TO:	Howard county health department 8930 Stanford Blvd. Columbia MD 21045	DATE:	9/18/2017		
		FSH JOB #:	4038		
		JOB NAME:	The woods at Triadelphia lot 4		
		REGARDING:	Revised septic design plan		
ATTENTION:	Jeff Williams/ Robert Freemon , Well and septic program	FROM:	Zach Fisch PE.		
<input type="checkbox"/>	FOR YOUR INFORMATION AND/OR USE AS PER YOUR REQUEST	<input type="checkbox"/>	FOR YOUR PICK-UP FROM FSH HAND DELIVERED TO YOU		
<input type="checkbox"/>	FOR YOUR REVIEW AND/OR COMMENT	<input type="checkbox"/>	FAXED TO YOU		
X	FOR YOUR APPROVAL AND/OR SIGNATURE	<input type="checkbox"/>	EMAILED TO YOU		
<input type="checkbox"/>	WHEN DONE, PLEASE RETURN THIS TO FSH	<input type="checkbox"/>	MAILED TO YOU		
<input type="checkbox"/>		<input type="checkbox"/>	SENT TO YOU OVERNIGHT / NEXT-DAY		
IMPORTANT REMARKS: 					
DEPT. / AGENCY	MEDIA / OBJECT	SETS	SHEETS (ITEMS)	DATE	ITEM DESCRIPTION
Health Dpt.	Prints	2	1		Revised septic design plan , Willow pond lot 10.

PLAN FOR SEPTIC & PUMP INSTALLATION
THE WOODS AT TRIADELPHIA

MEMORANDUM

RE: Woods at Triadelphia, Lot 4
12502 Triadelphia Rd.
Ellicott City, MD 21042

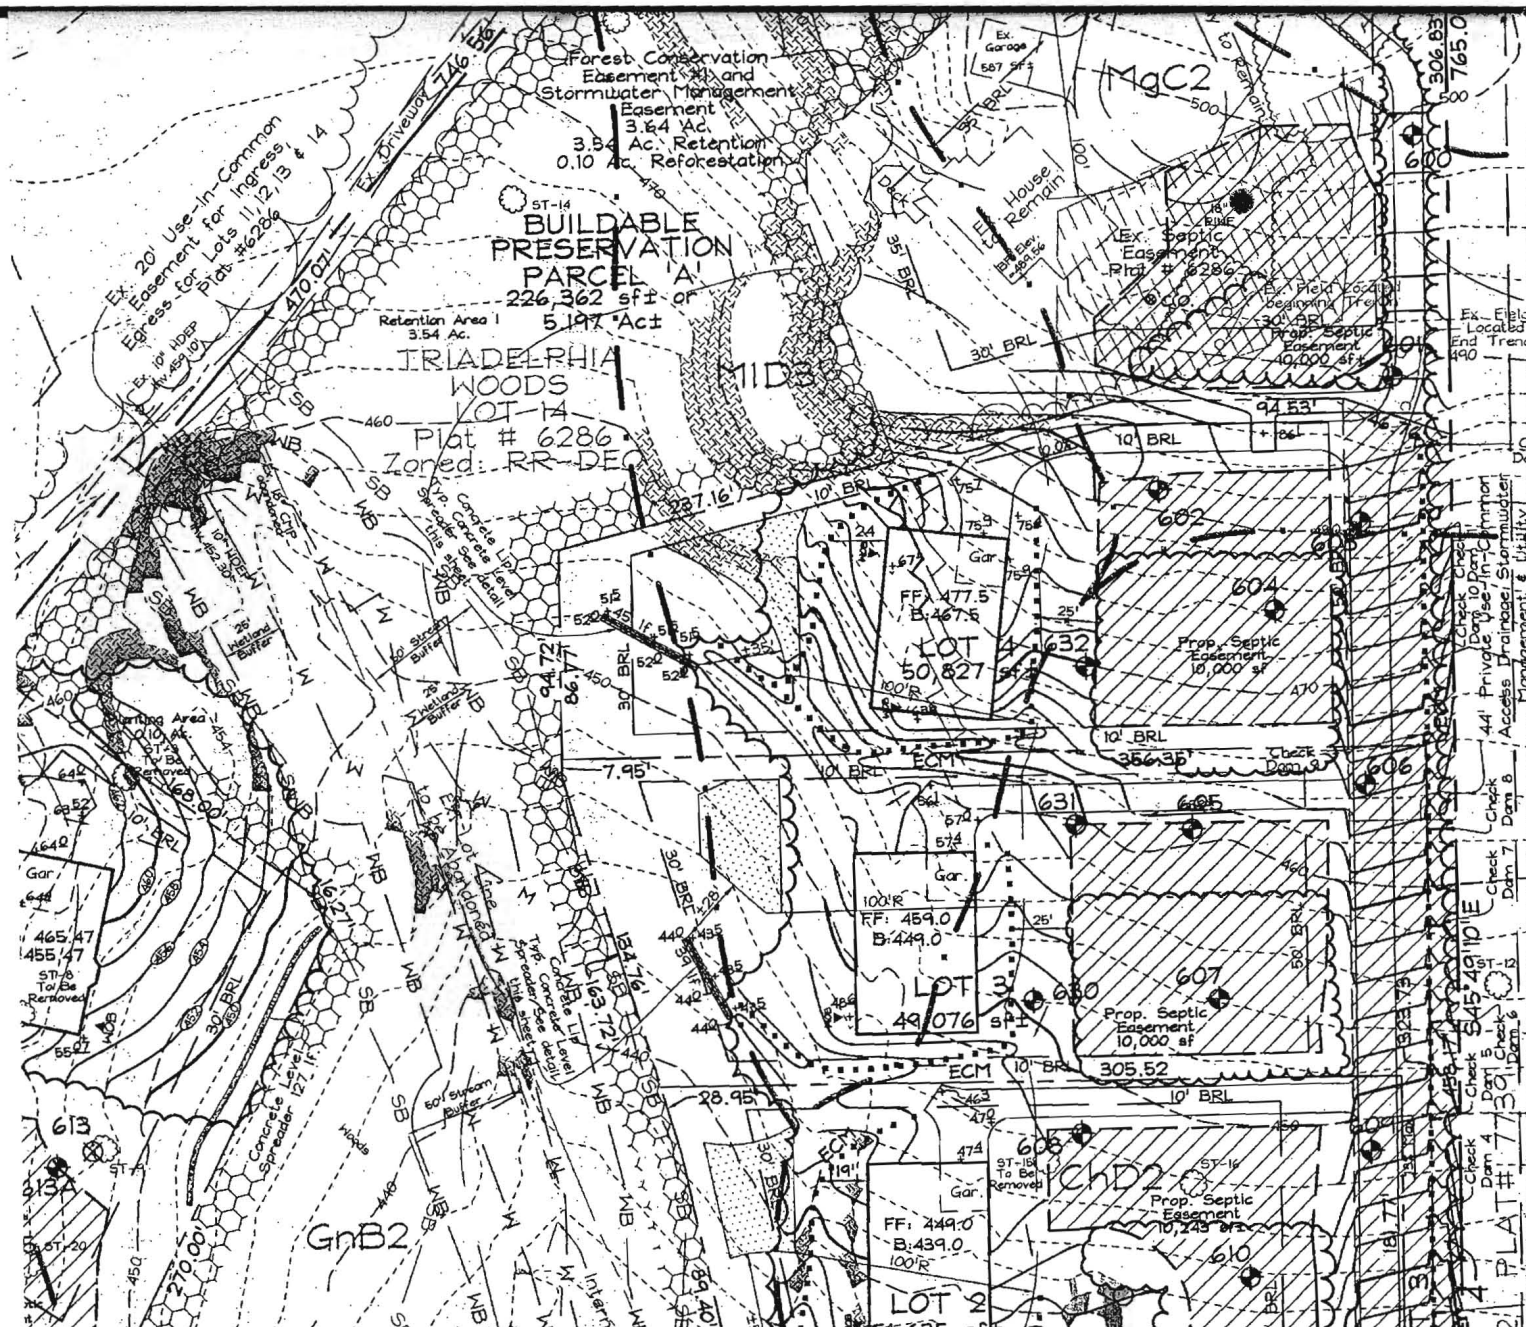
As I mentioned in our tell conversation, the level spreaders that are concrete level spreaders do not infiltrate. As you can see the flow off the level spreader on lot 4 will bypass the well box on lot 3 and it does not discharge directly onto it. Also, the existing well on lot 3 is about 52 feet away from the level spreader. When lot 3 septic design plan was prepared we showed the level spreader for lot 4.

PLAN VIEW

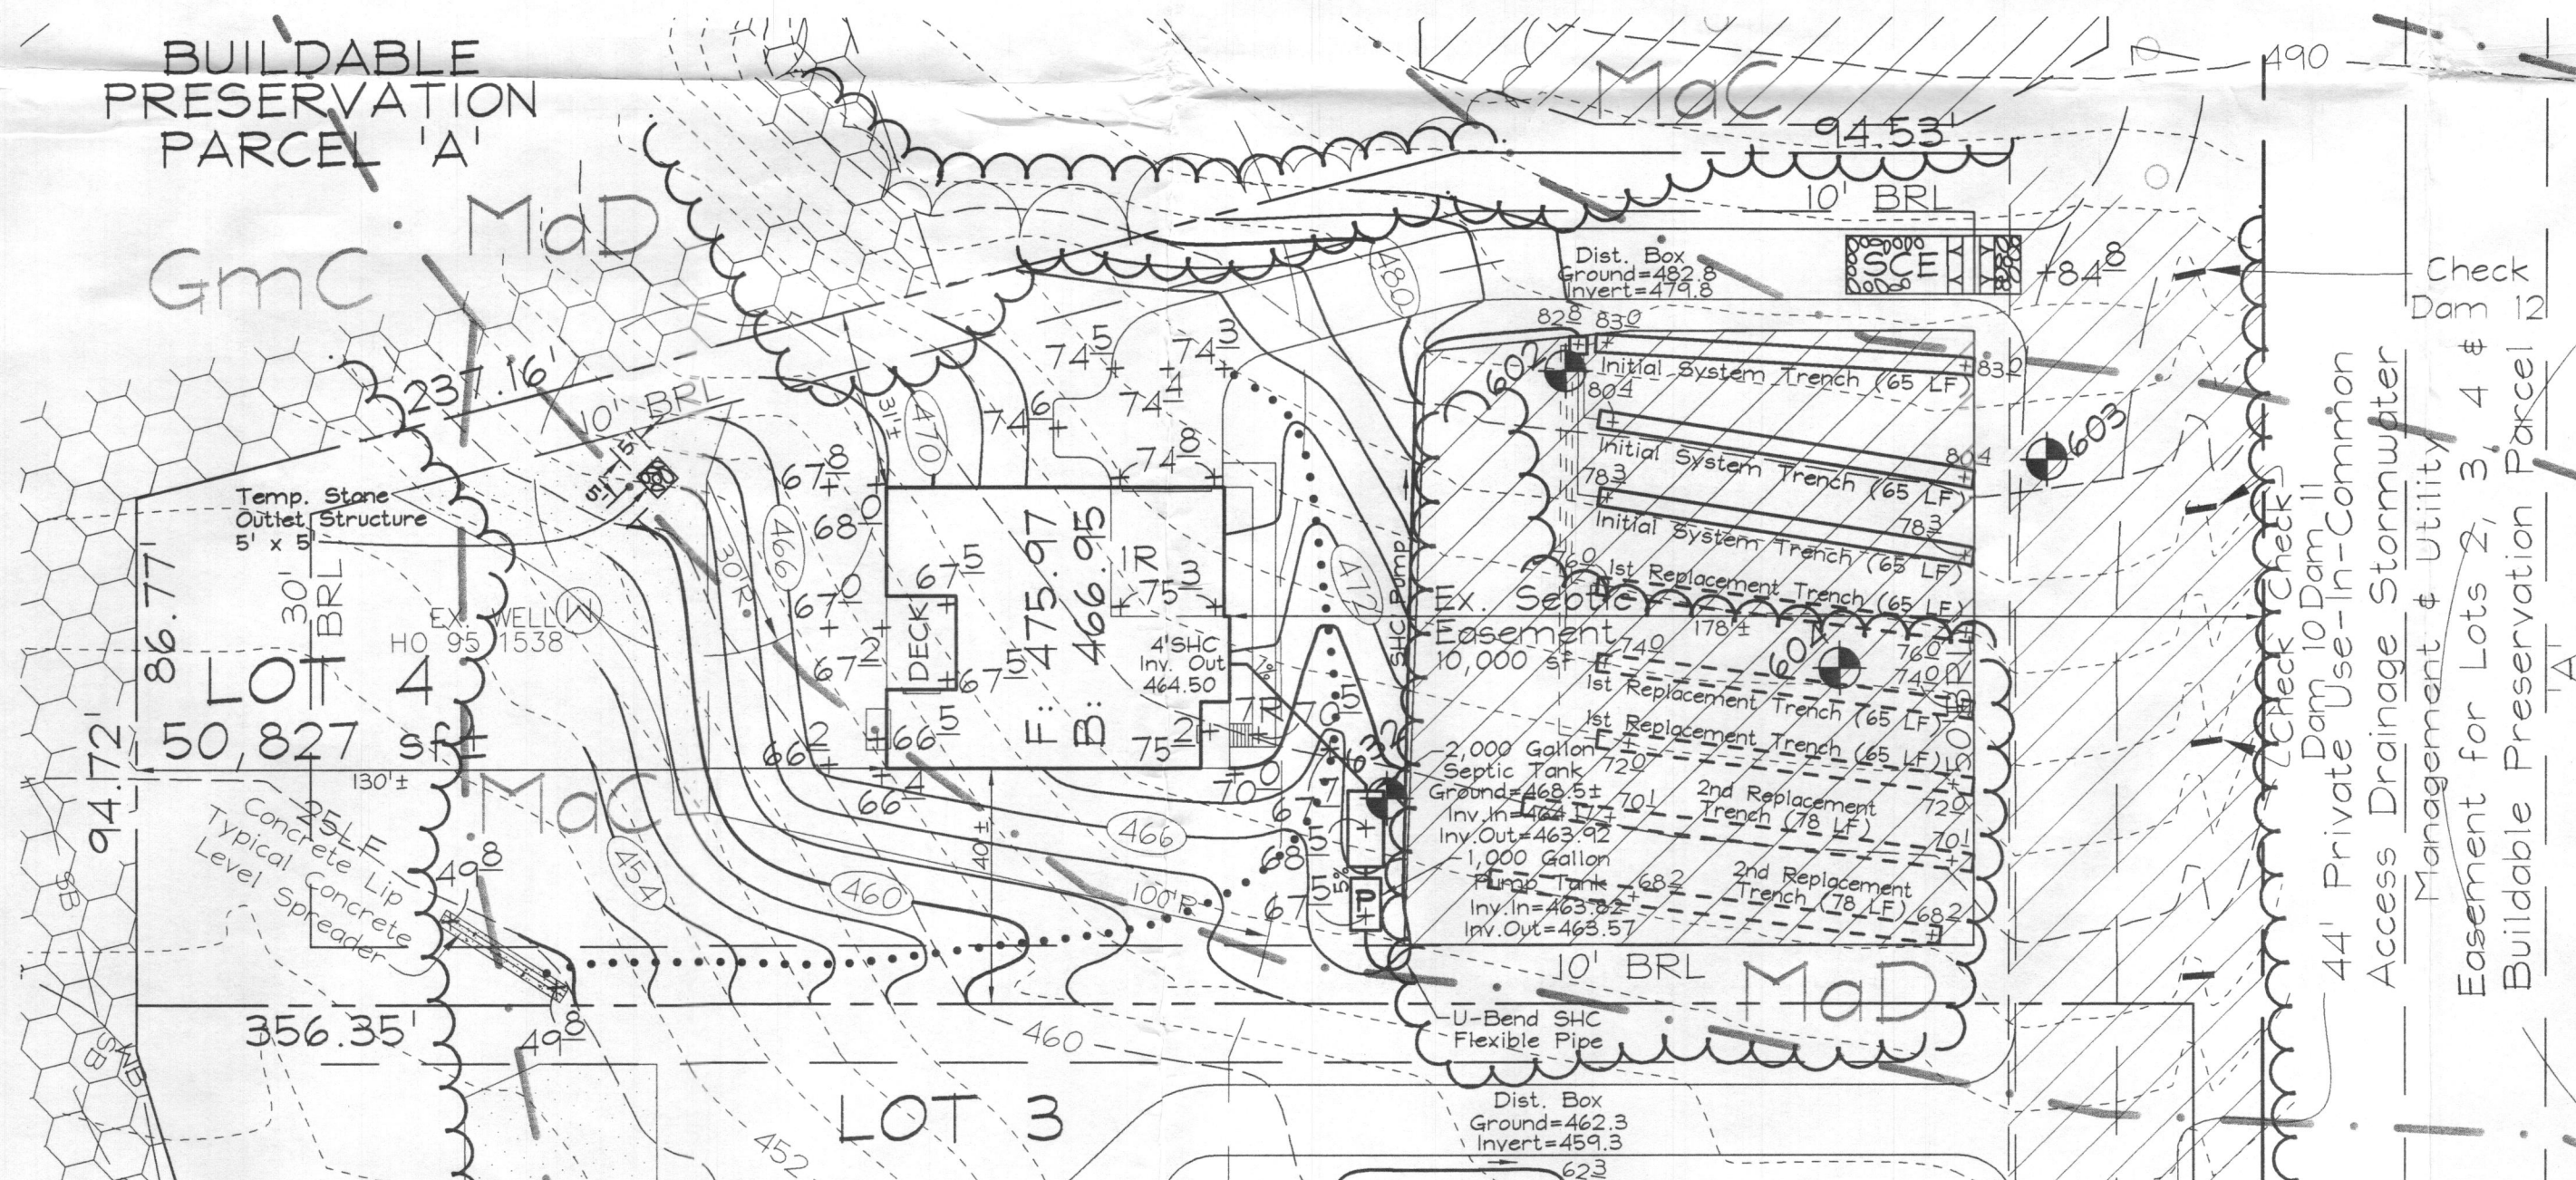
After reviewing the plan, I concur with Spencer that the tank is far too close to the graded swale. It should be 25' away from a swale, same as the sewage disposal area. We will allow you to get it around 15' away if you move the tanks just to the inside of the sewage disposal area.

Regarding the level spreader: see the attachment, which is the most recently approved perc certification plan signed in January 2008 that you prepared. The level spreader is farther away from the well box on that plan than it is on this plan. That plan was completed at the time of the subdivision plat and the level spreaders were shown on that plan to match their location on the plat supplemental. The location you show on this plan is too close to the well box. We will allow it to be closer than 50' as long as it is in the same location as it was shown on the perc cert and the plat supplemental.

- ✓ There needs to be a 30ft and 100ft arch around the well and well box.
- ✓ Elevations at each perc hole must be labeled.
- ✗ The septic tank cannot have more than 3' of earth cover over it. If more than three feet is necessary a heavy load bearing tank will be required.

- ✗ The concrete level spreader must stay at least 50' from the well box.
- ✓ The proposed level spreader in the legend does not match what is shown on the plan.

- ✓ The septic tank needs to be further away from the swale. The extra space in the SDA (not used by replacement trenches) may be used for the septic tank and pump tank.

We addressed the rest of the drafting comments except the weep hole in the pump tank or showing the valves and fittings for the pump. Before we were not required to go to this level of design detail.
